Economic Commission for Europe**Inland Transport Committee****World Forum for Harmonization of Vehicle Regulations****Working Party on Passive Safety****Sixty-second session**

UN Regulation No. 14 (Safety-belt anchorages)**Proposal for 09 series of amendments to UN Regulation
No. 14 (Safety-belt anchorages)****Submitted by the experts from Germany***

Model A

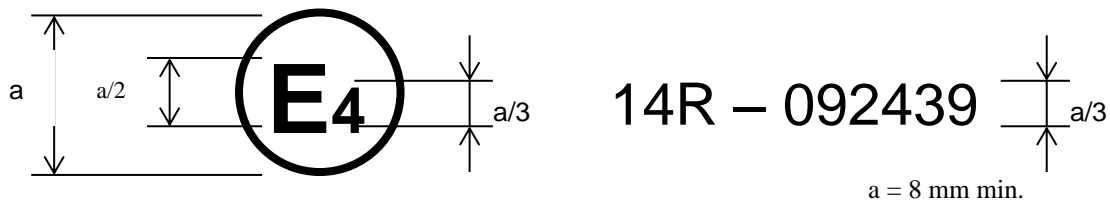
Annex 2, amend to read:

The above approval mark affixed to a vehicle shows that the vehicle type concerned has, with regard to safety-belt anchorages, been approved in the Netherlands (E 4), pursuant to UN Regulation No. 14, under the number 092439. The first two digits of the approval number indicate that UN Regulation No. 14 already included the 08 series of amendments when the approval was given.

Model B

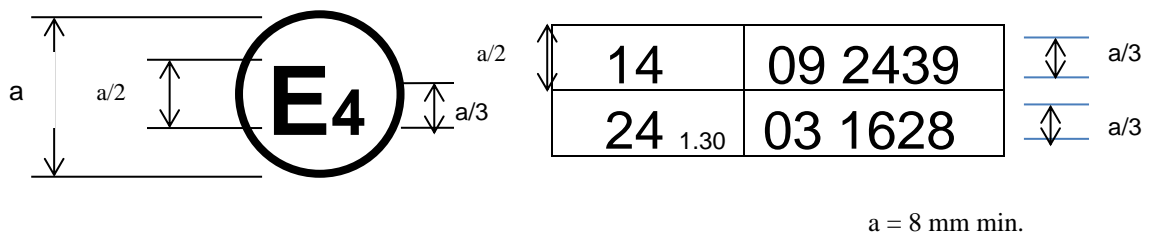
The above approval mark affixed to a vehicle shows that the vehicle type concerned has been approved in the Netherlands (E 4) pursuant to UN Regulations Nos. 14 and 24*. (In the case of the latter Regulation the corrected absorption co-efficient is 1.30 m⁻¹). The approval numbers indicate that on the dates on which these approvals were granted, UN Regulation No. 14 included the 09 series of amendments and UN Regulation No. 24 was in its 03 series of amendments.
